1394B “LEGACY CONNECTOR” SECTION
PROPOSAL FOR MODIFICATIONS TO WORDING IN SECTION 4.2.1.1,
AND FIGURE 4-7
(Ref. IEEE 1394-1995 AS BASIS)
BILL NORTHEY, JULY 19, 1999

Proposed changes are highlighted

Figure 4-6 Connector Insertion Wafer

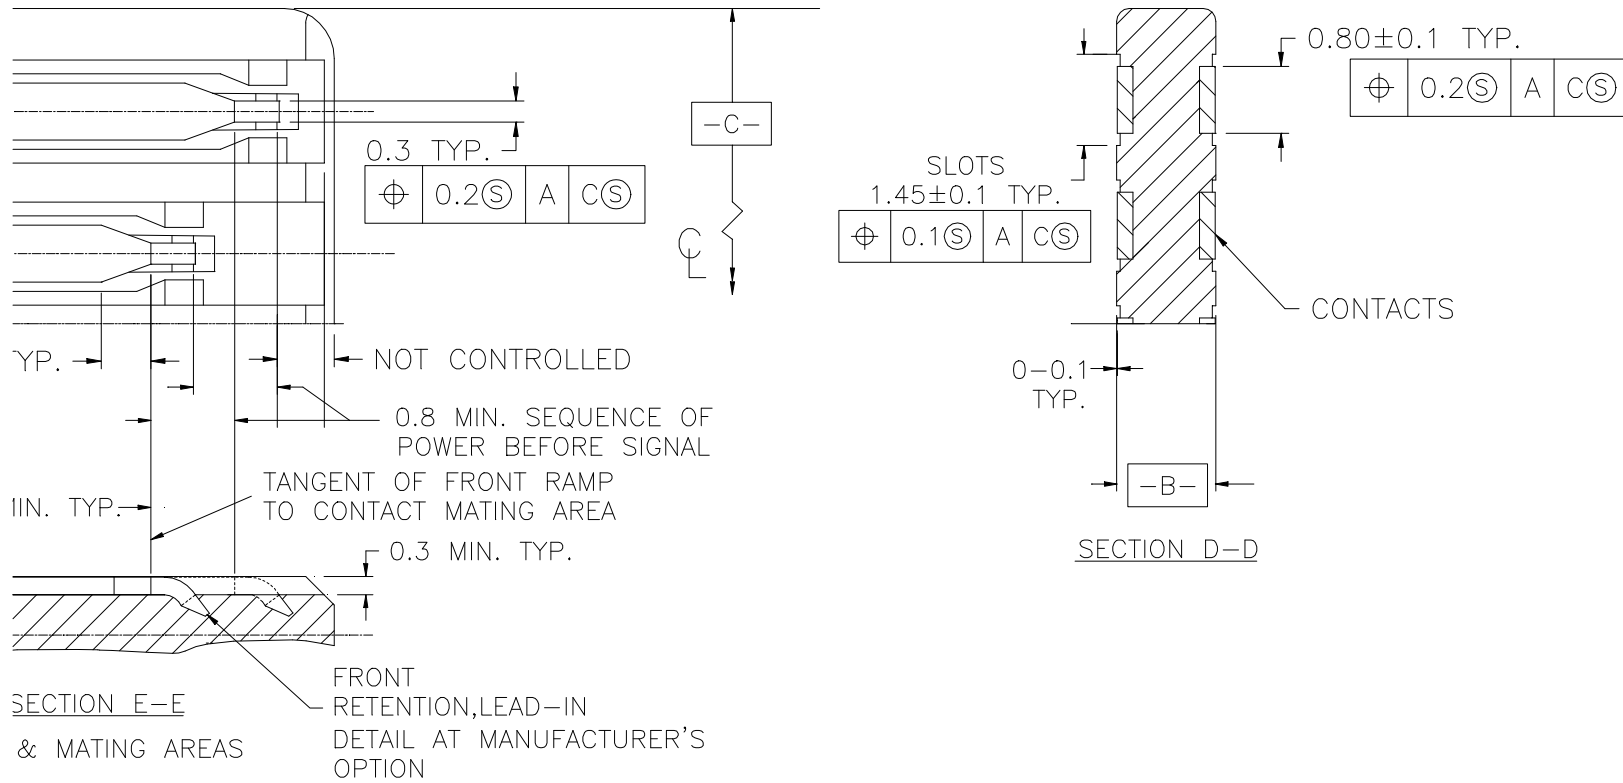
Add to Notes: 3 – Hertzian contact profile shown for reference only.

Add Figure 4-7a as shown here:

FIGURE 4-7A – SOCKET INSERTION WAFER DETAILS

Both the Hertzian and Non-Hertzian variations shown in Section D-D and Section E-E provide alternative and acceptable constructions of “plug compatible” designs. Regardless of the contact variation, the connectors must adhere to the performance criteria defined in 4.2.1.3.

It is likely that there will be several variations of sockets to meet differing mounting orientation requirements, panel/bulkhead mounting, and/or assembly techniques. The socket contacts may also vary, as shown in Alternative Section D-D of Figure 4-7a, while remaining plug compatible. Regardless of these variations, the connectors must adhere to the performance criteria defined in 4.2.1.3. The holes and patterns (footprint) for the mounting of some of the possible versions of connectors to the printed circuit board (PCB) are recommended in annex I.
